<b>NEW YORK</b> STATE OF OPPORTUNITY.	<b>Department of Transportation</b>	<b>ENGINEERING INSTRUCTION</b>	<b>EI</b> <b>21-004</b>
<b>Title: NYSDOT LRFD BRIDGE DESIGN SPECIFICATIONS - 2021</b>			
		Approved:  James Flynn III, PE Deputy Chief Engineer (Structures)	2-2-21 Date

**PURPOSE:** This EI officially adopts the NYSDOT LRFD Bridge Design Specifications – 2021 for use in New York State and announces the availability of "NYSDOT LRFD Blue Pages" dated January 2021.

**2021 NYSDOT Blue Pages**

Figure A3.10.3.1-1. Downstate Zone Guidelines Rock and Soil Sites

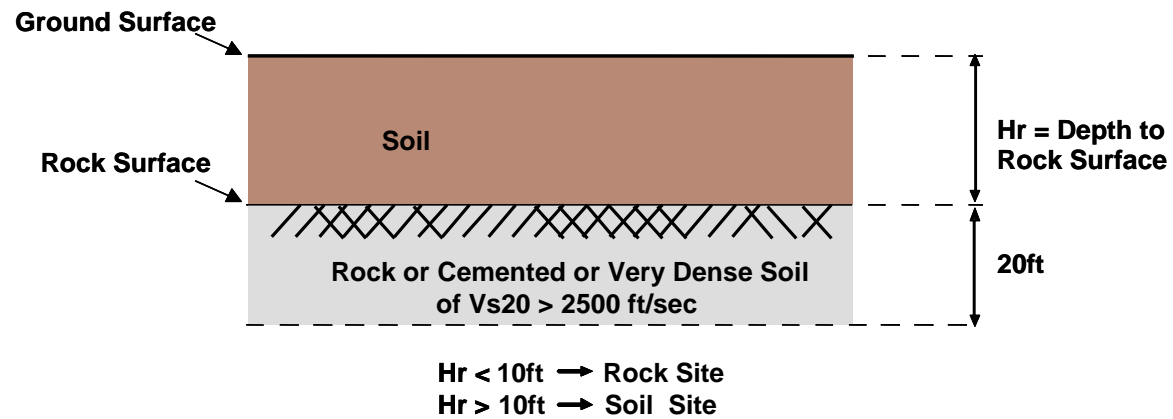
The depth of the rock surface below the ground surface of the site is labeled  $H_r$  in these Guidelines (see Figure A3.10.3.1-1).

Determining that the rock surface has been reached requires calculating  $\bar{V}_{s20}$ , which is defined as follows (see Figure A3.10.3.1-1):

**Figure A3.10.3.2-1. Downstate Zone Guidelines Option for Soil Site on Rock Class B Followed Within 40 ft. by Rock Class A/VHR**

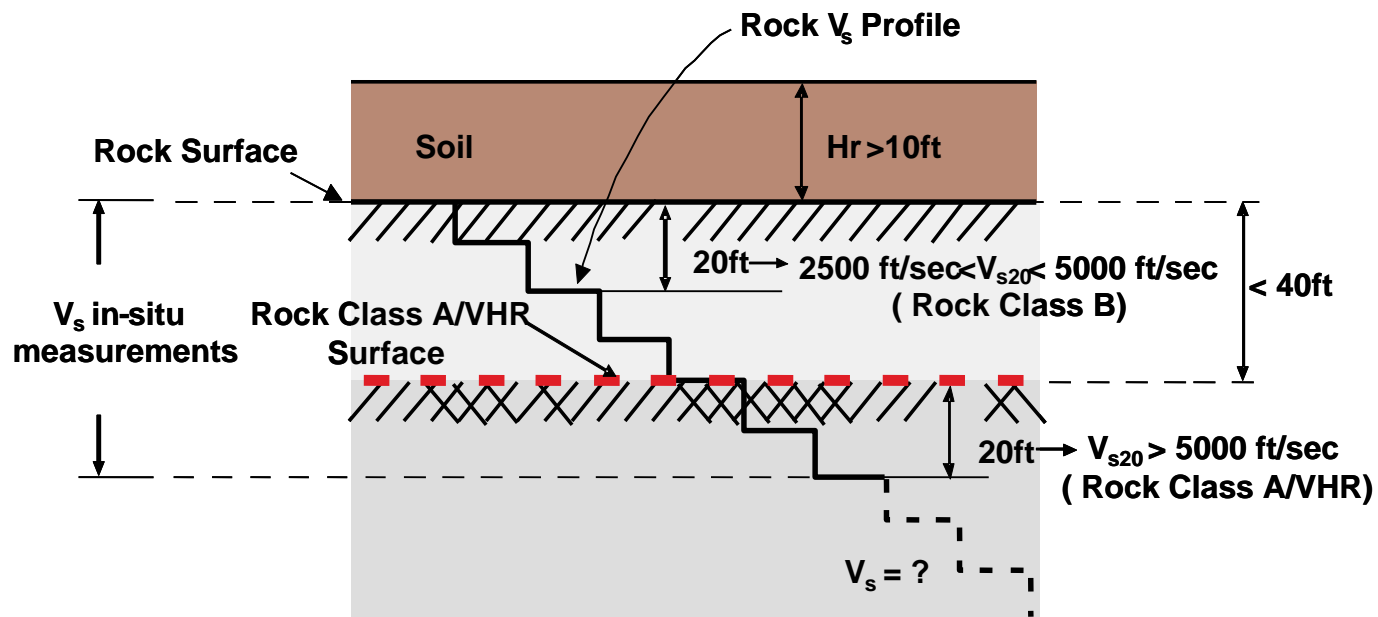
If  $H_r \leq 100$  ft. and the measured averaged shear wave velocity  $\bar{V}_{s20}$  indicates Rock Class B directly beneath the soil, but Rock Class A/VHR is found by drilling at a depth below the rock surface not greater than 40.0 ft., the Engineer shall have the option to specify that the soil profile is on top of Rock Class A/VHR instead of Rock Class B (see Figure A3.10.3.2-1), for the purpose of selecting the generic spectral accelerations (see Article A3.10.4), and the Peak Ground Acceleration (PGA) for liquefaction evaluation (see Article A3.10.2.2). To exercise this option, drilling must continue at least 20.0 ft. below the Rock Class A/VHR surface shown in Figure A3.10.3.2-1.
